March 19, 2019

Project No. 12091-01

**Subject:** *Preliminary Geotechnical Evaluation and Response to City Review Comments for Proposed San Pedro Distribution Center, 1599 W. John S. Gibson Boulevard, Los Angeles, California*

## **5.0 RESPONSE TO CITY REVIEW COMMENTS**

ALAN DANG  
Structural Engineering Associate II

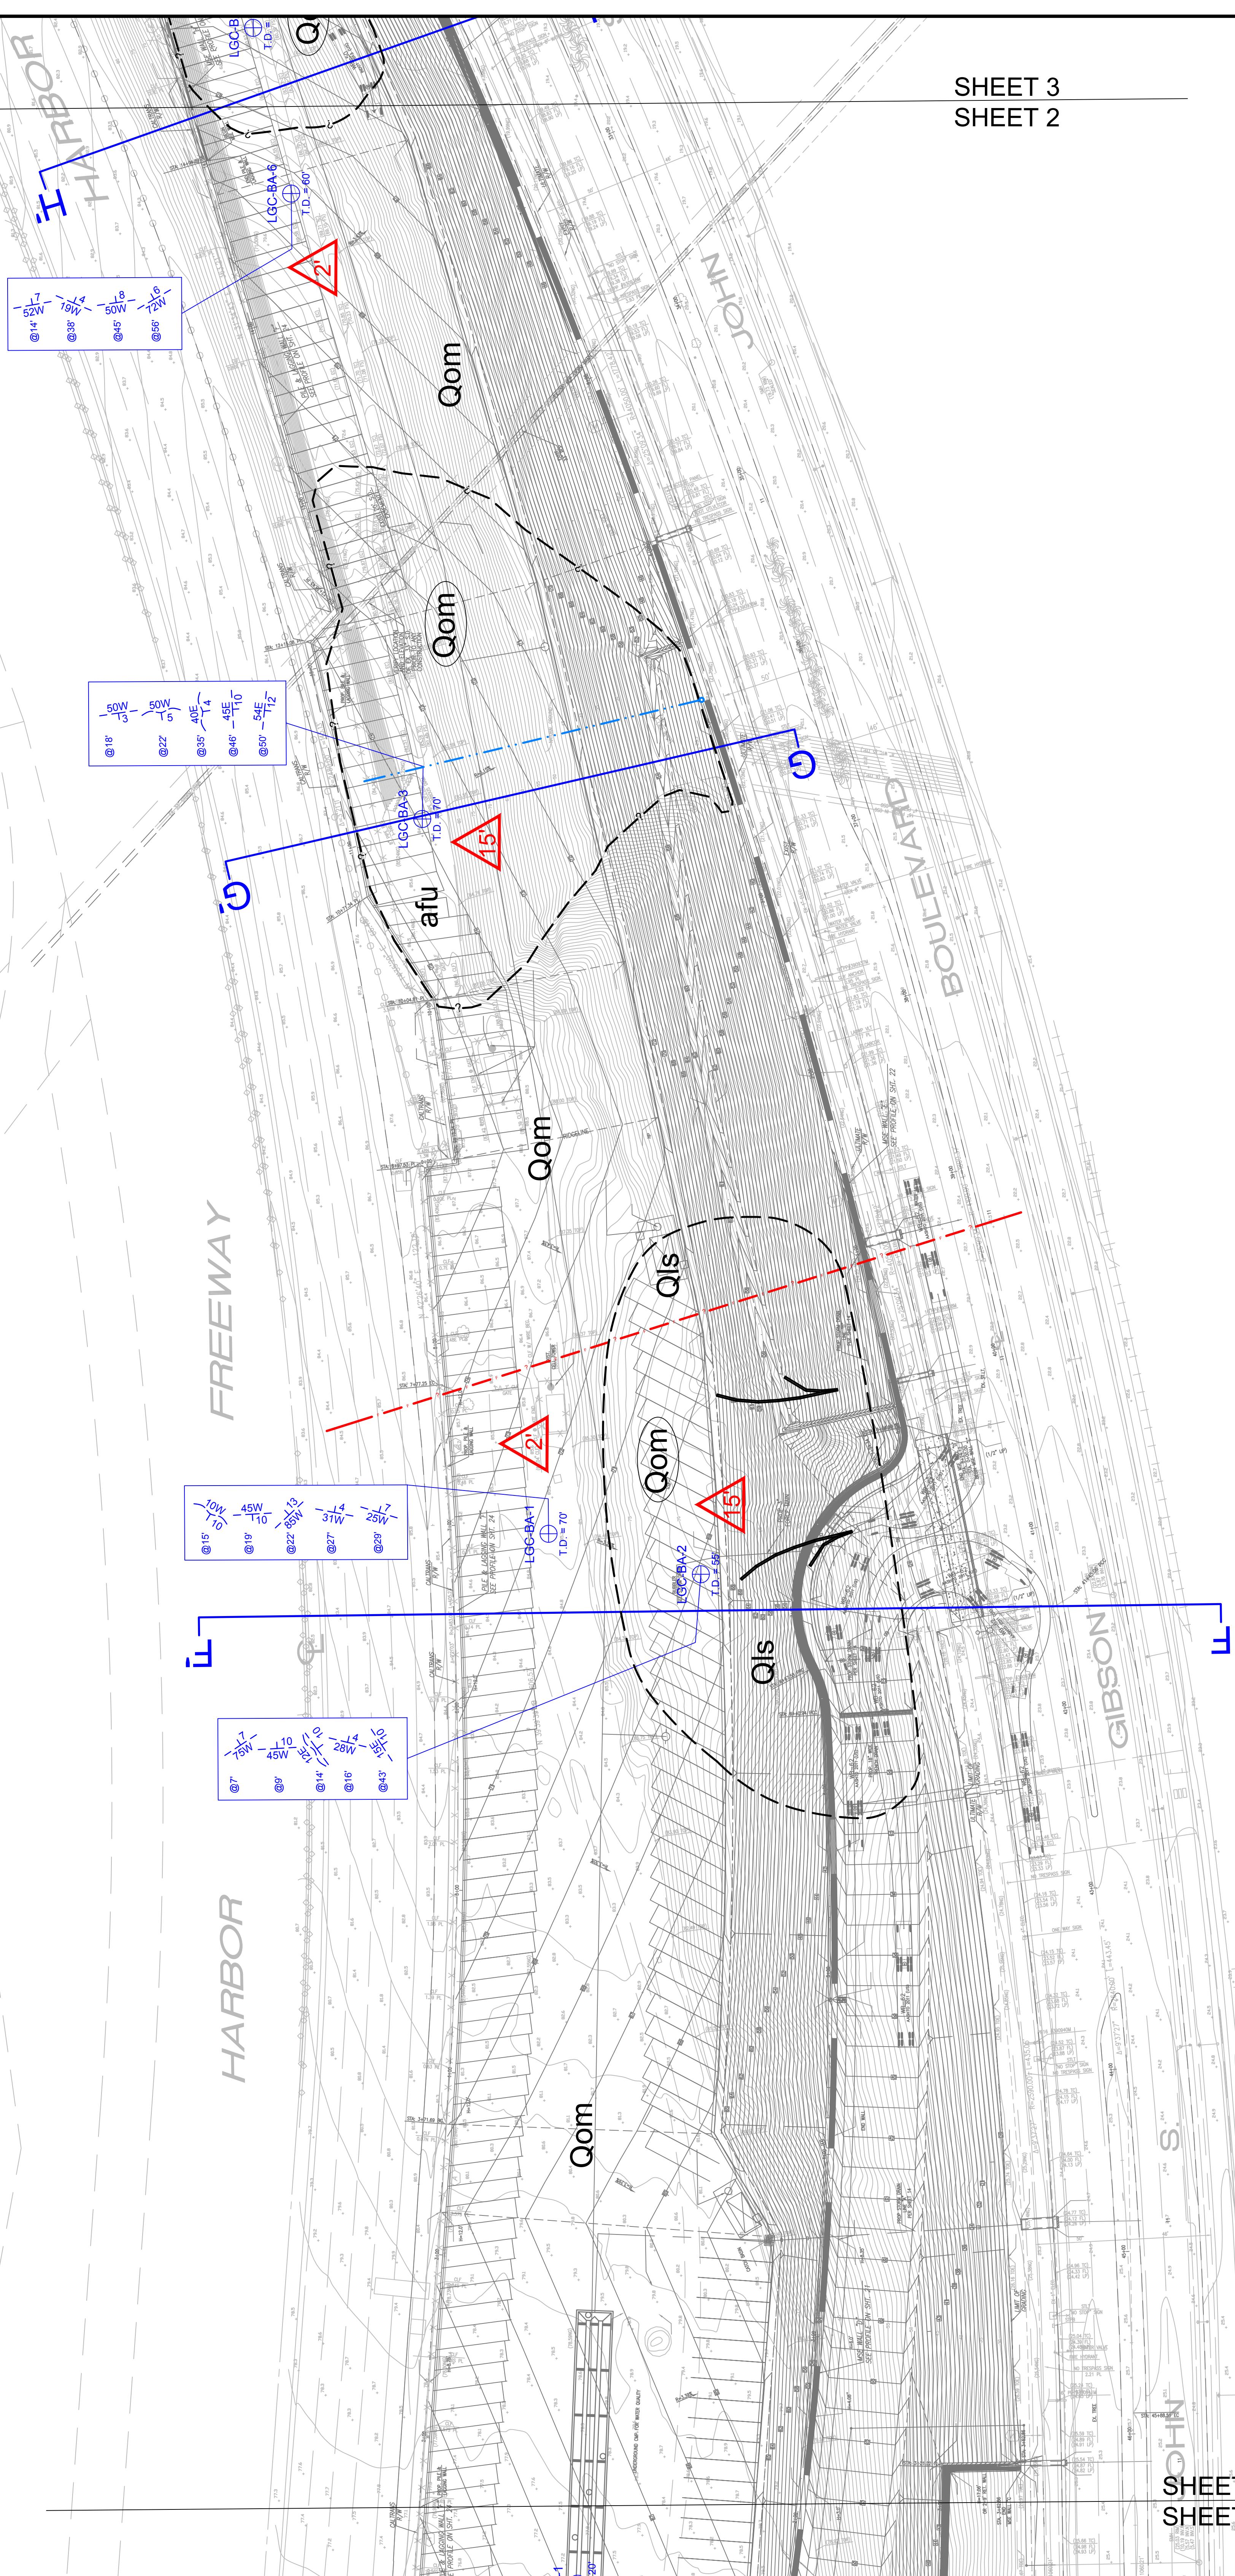
“No map was provided with the current update report reflecting the proposed site conditions. Provide recommendations and revise the plan(s) and cross sections(s) for providing the required building setback from the toe of the ascending slope as specified by Code Section 1808.7.1.”

"Provide a geologic map and cross sections that are based upon conceptual grading or site development plans, to illustrate all proposed and existing contours relative to the planned grading and/or construction, along with all off-site slopes and conditions that could adversely affect the stability or safety of the site (7006.3.2). The geologic map and cross sections shall depict the top and bottom of slopes; lithologic contacts; bedding attitudes; locations of slumps, landslides, or faults relative to the subject site; existing and proposed topographic profiles; existing and proposed structures; and, required Code setbacks. (7006.3.2)"

Refer to the attached Geotechnical Map (Sheets 1 through 3). No building structures are planned for the site.

Refer to the attached Geotechnical Map and Geotechnical Cross Sections (Sheets 1 through 5). No building structures are planned for the site.
